# Access Compliance Report

## Public Rights-of-Way

### (Curb Ramps)

Intersection ID: 50583	Main Street: GRAND_FIR_RD	Cross Street: LONGSTRAW_RD	Location: NE
ADA ID: 32F45B05A69D	Ramp Type: Perp	Initial Pass/Fail: Fail	Overall Compliance: No
Severity Score: 22.5			
Codes/Mitigation Info/Possible Solution		Field Measurements/Component Compliance

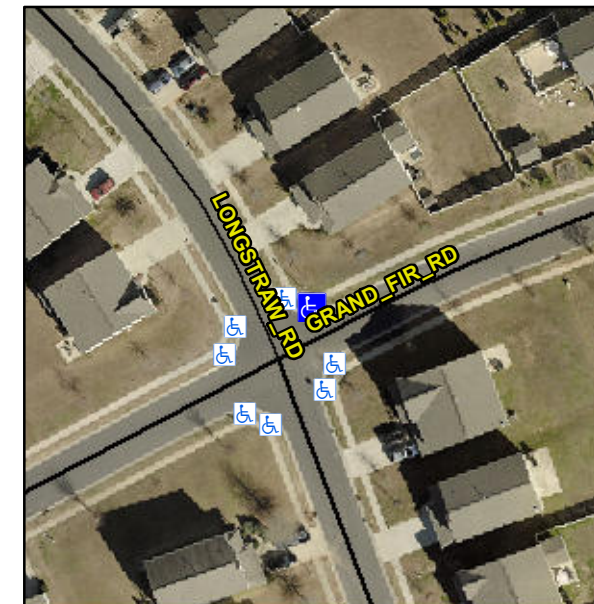
**Not Found, R304.5.1, R304.2.2, R304.5.3**

Compliance	Description	Data	Compliance	Description	Data
N/A	Ramp Length (in)	48.0	No	Ramp Slope (%)	8.5
No	Ramp Width (in)	47.5	No	Ramp XSlope (%)	4.1
N/A	Flare Type LT	N/A	N/A	Flare Type RT	N/A
N/A	Flare Slope LT (%)	N/A	N/A	Flare Slope RT (%)	N/A
N/A	Flare Traversable LT?	N/A	N/A	Flare Traversable RT?	N/A
N/A	Landing Length (in)	N/A	N/A	DWS Provided?	N/A
N/A	Landing Width (in)	N/A	N/A	DWS Contrast?	N/A
N/A	Landing Slope (%)	N/A	N/A	DWS Length (in)	N/A
N/A	Landing X Slope (%)	N/A	N/A	DWS Full Width?	N/A
N/A	Landing Curb? (Y/N)	N/A	N/A	DWS Offset (in)	N/A
N/A	Shared Landing?	N/A			
N/A	Gutter Ponding?	N/A	N/A	Gutter Slope (%)	N/A
N/A	Gutter Lip Ht (in)	N/A	N/A	Gutter X Slope (%)	N/A
N/A	Painted X Walk1?	No	N/A	Painted X Walk2?	N/A
	X Walk 1 Direction	To S		X Walk 2 Direction	N/A
N/A	X Walk 1 Width (in)	N/A	N/A	X Walk 2 Width (in)	N/A
	X Walk 1 Slope (%)	2.6		X Walk 2 Slope (%)	N/A
	X Walk 1 X Slope (%)	2.1		X Walk 2 X Slope (%)	N/A

**Remove & Replace Entire Ramp.**
